C0960-006
April 7, 2021

**Re: Request for Site Review, Conditional Use & Amended Subdivision Permits
Proposed Multi-Family Development, 105 Bartlett Street, Portsmouth, NH**

PDMH9 (5' DIA)
NO SCALE

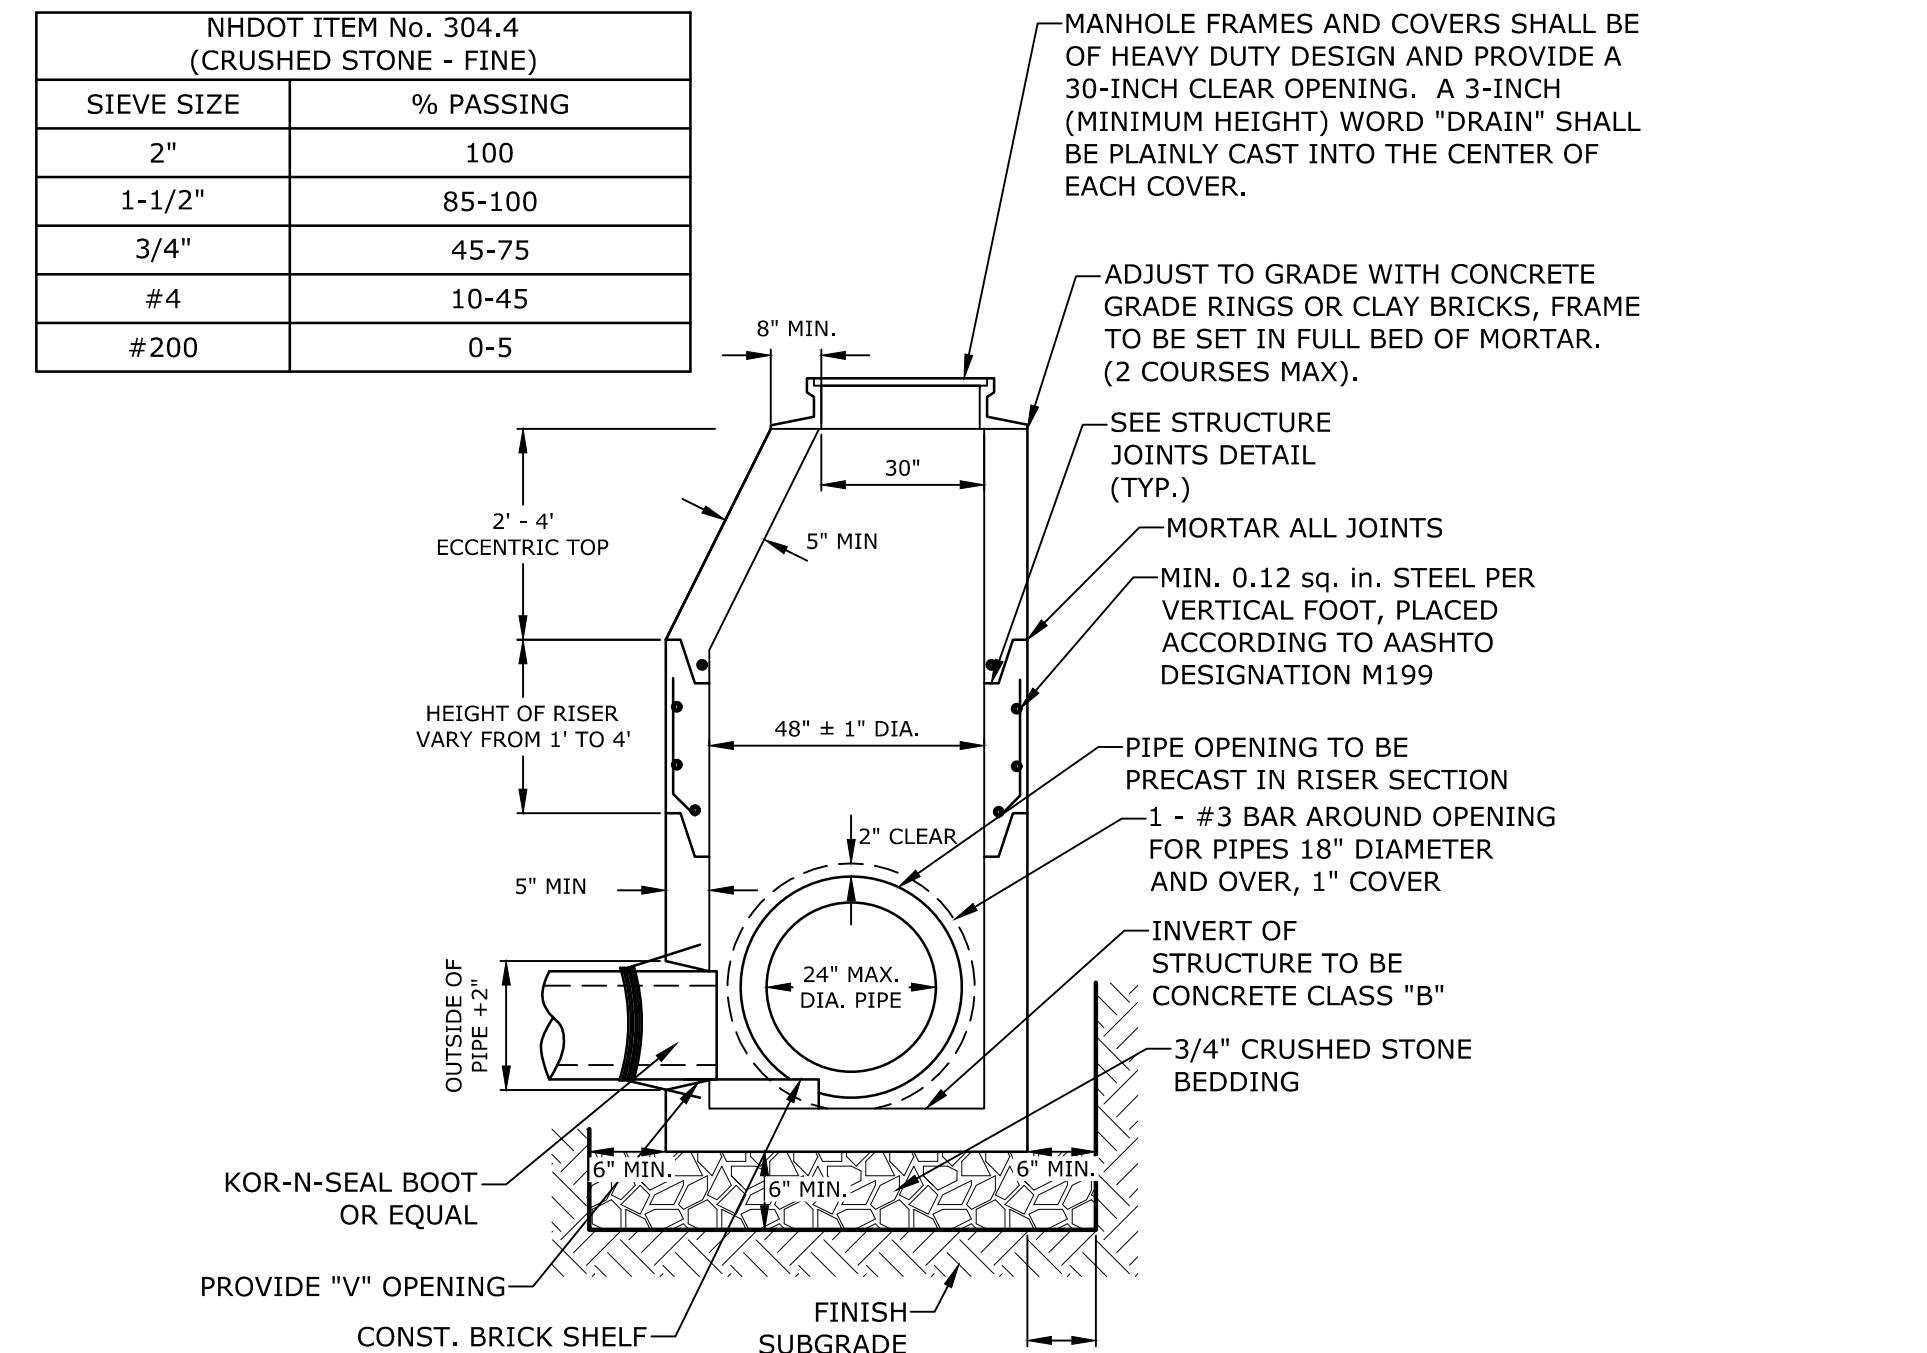
13	The detail for PDMH9 on Sheet C-506 shall be updated to the satisfaction of DPW.	A trash grate has been added to the outlet structure detail PDMH9, as requested by DPW	C-506
14	The plan should note either signage or pavement markings that signify fire and emergency access locations on the trail.	Pavement markings to signify fire and emergency access locations on the trail have been added to the plans and details.	C-102.2 & C-504
15	The lighting plans and details shall updated to include screening of light trespass onto abutting properties, as necessary.	Lighting plans have been revised to include a type IV distribution for the parking lot fixtures in order to cutoff back light trespass onto abutting properties.	C-105
16	The plans shall be updated to reflect that the applicant shall either complete the greenway trail connection to the lot line on the northeast side of the lot as part of this project or the applicant shall agree to contribute a fee for the design, permitting and construction of the trail to be completed by the City in the future.	The plans have been revised to reflect that the applicant will complete the greenway trail connection to the lot line on the northeast wide of the lot as part of this project.	C-102.2 & C-103.2
